REZ-2025-102340

DRB III Trucking LLC

Report Drafted June 15, 2026

I. Executive Summary

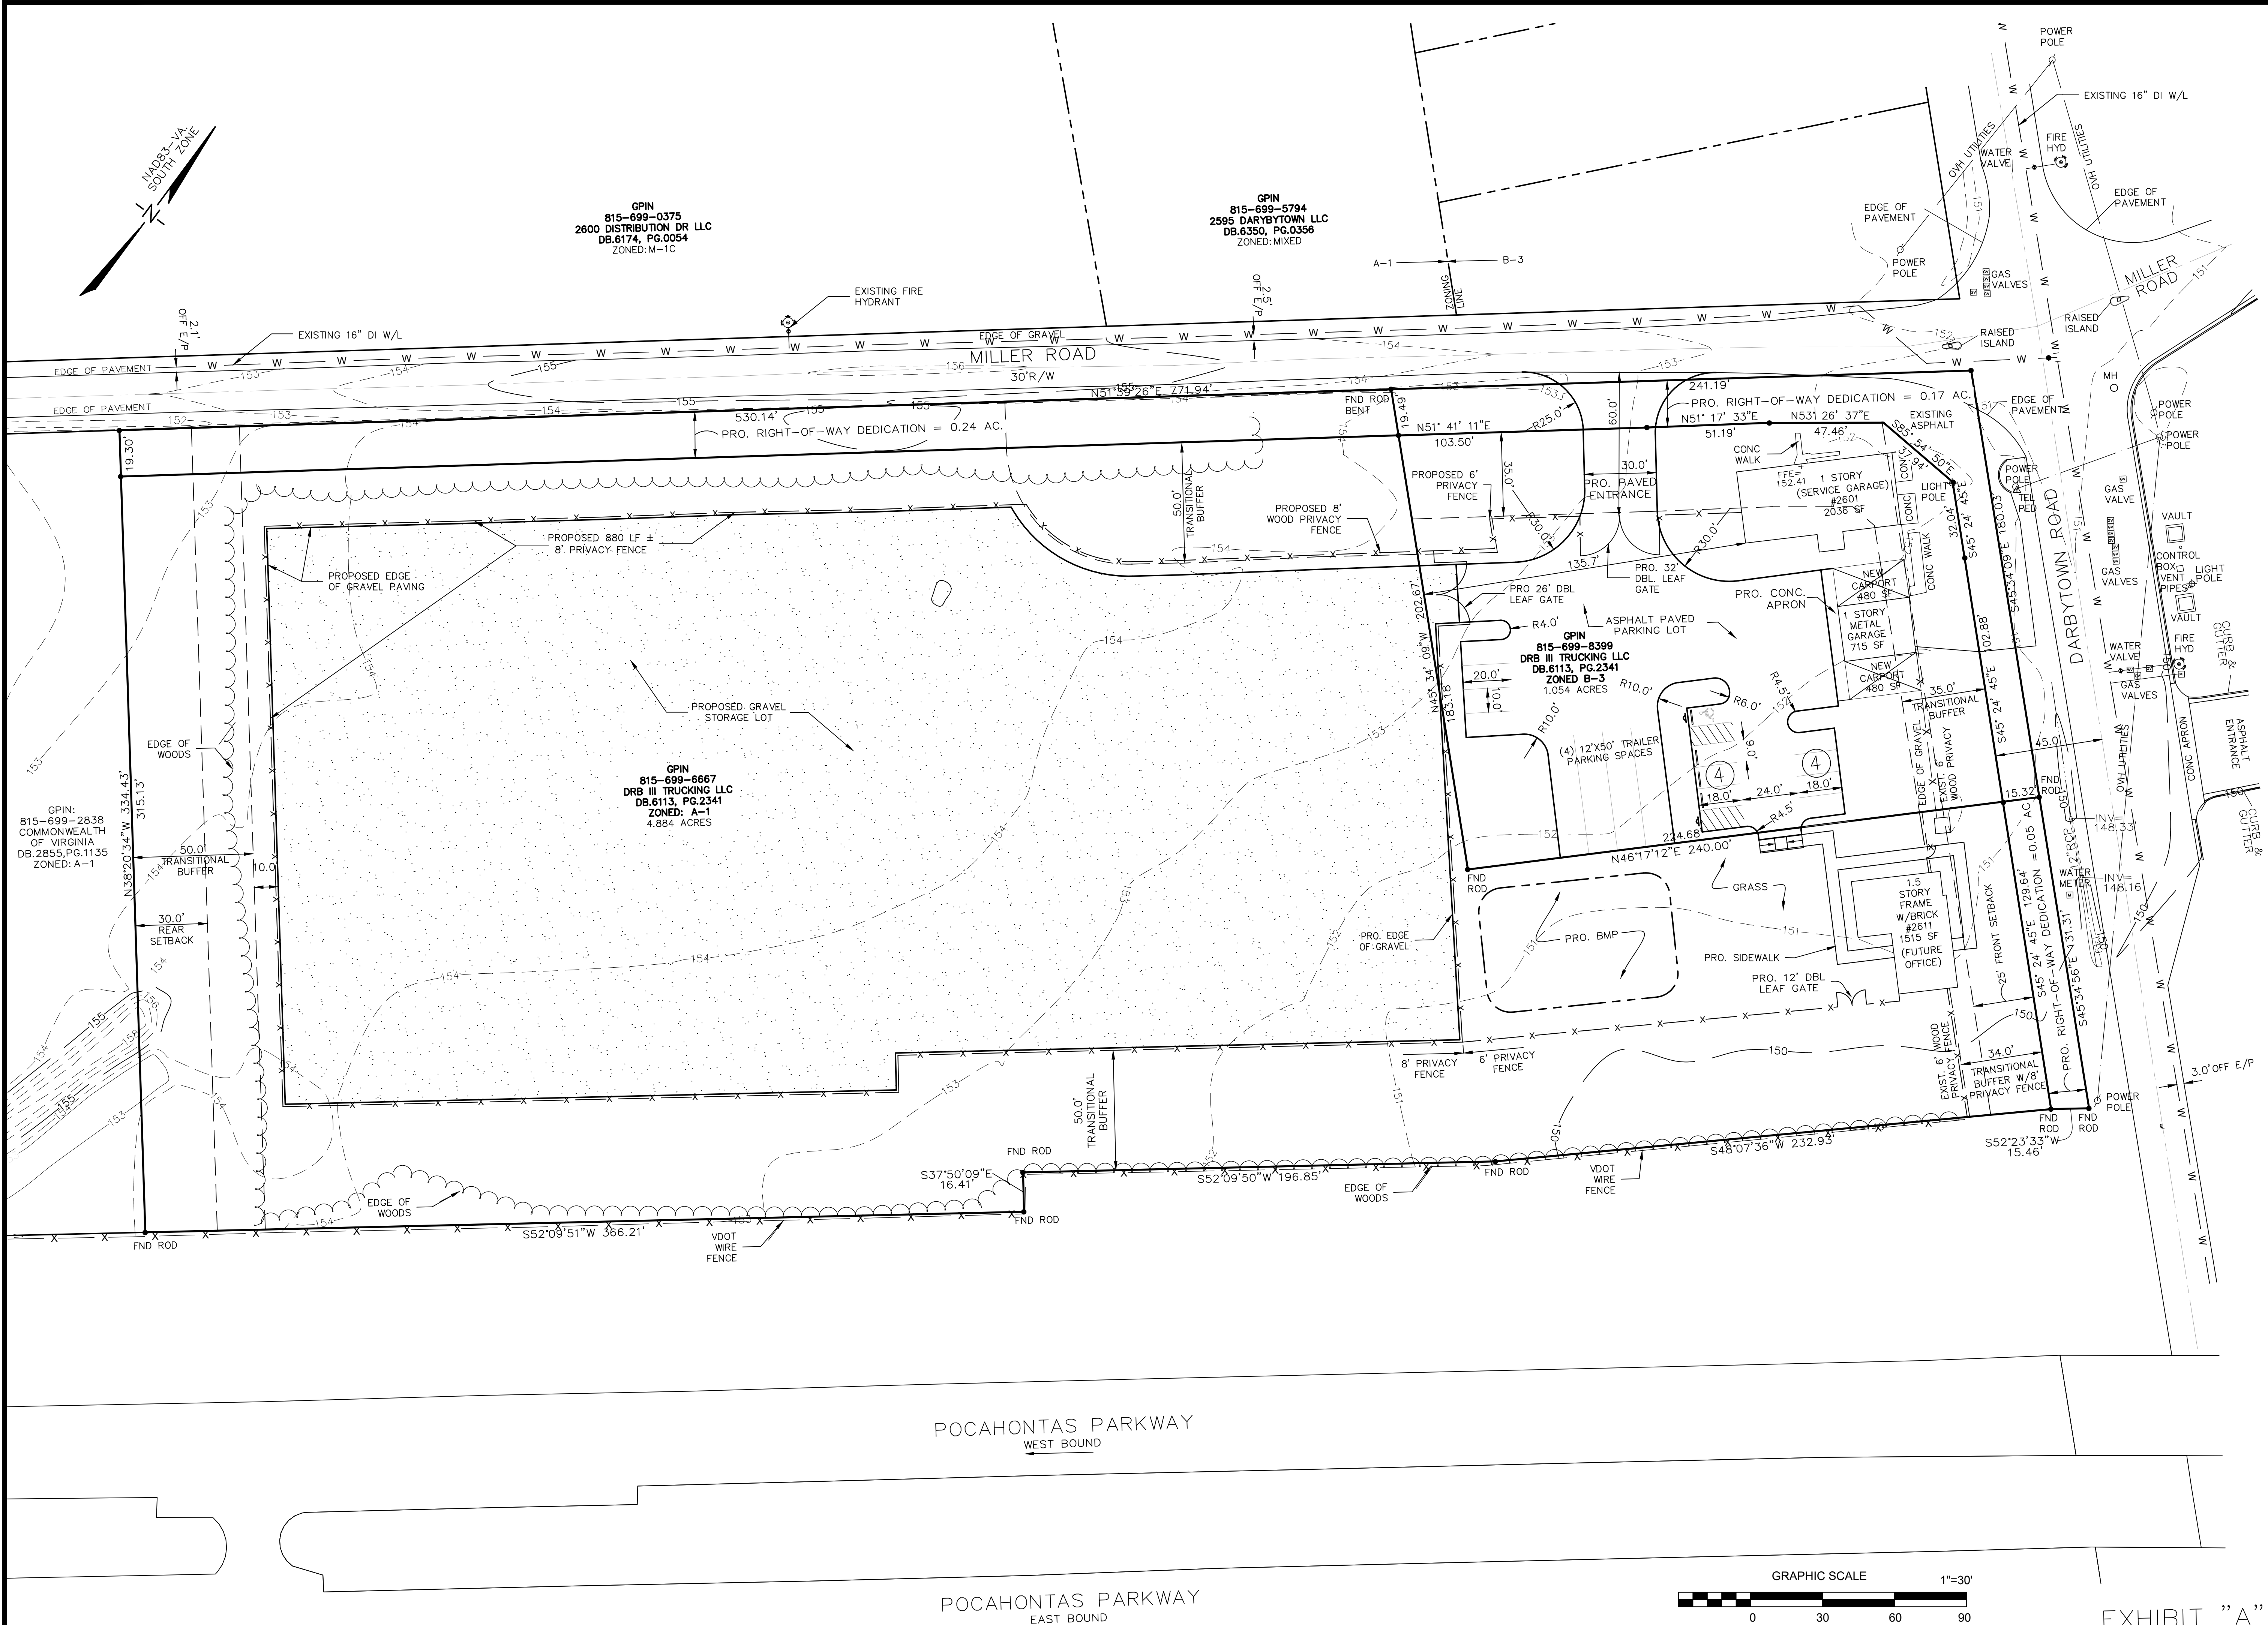
The proposed layout would convert the majority of the site to a gravel storage yard. Based on the proposed use, this modification would over intensify the site and would not be consistent with the intent of a Planned Industry classification. While the area has several planned industrial uses, the proposed zoning would allow the more intensive heavy industrial uses and commercial uses to encroach upon the residential uses along Miller Road to the southwest with little assurances to minimize visual and operational impacts. The applicant is encouraged to address the outstanding items, concerns, and open questions below to provide a designed, coordinated development.

- **Buffers** – In keeping with other Planned Industry style development in the area, the applicant should consider extending the 50' buffer along the entire length of Miller Road. Additionally, the applicant should consider ensuring preservation of the existing tree areas denoted as 'Edge of Woods' on the conceptual plan. The Transitional Buffer language states the trees are shown on the concept plan but does not provide assurances to keep them;

- **Fencing** – Although this is ultimately an issue to be resolved during the Plan of Development process, it remains unclear how the applicant's proposed fencing would adequately screen tall items being stored;

- **Trash Pickup** – The plans do not show a dumpster on the site, and the minor repairs would generate trash and fluids that would require proper disposal;
